UNITED STATES PATENT AND TRADEMARK OFFICE

Office Action Summary

10/035,828

SANDHU, Gurtej S.

FIG.1

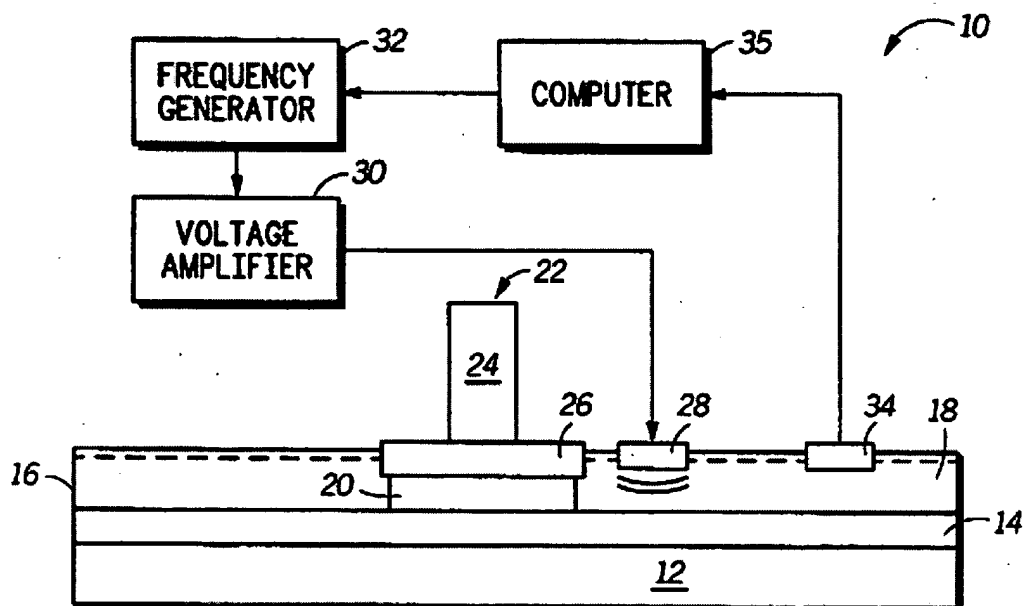
5. Claim 14 as well as understood is rejected under 35 U.S.C. 102(b) as being anticipated by Yu et al.'5,399,234.

With reference to Figure 1, col. 5, lines 1-22, Yu discloses the claimed invention. Please note that the changes in acoustic wave velocity inherently include an emission spectrum of the byproduct because as the reaction due to the emission of the byproduct proceeds the concentration of silanol in polishing slurry 14 steadily increases.
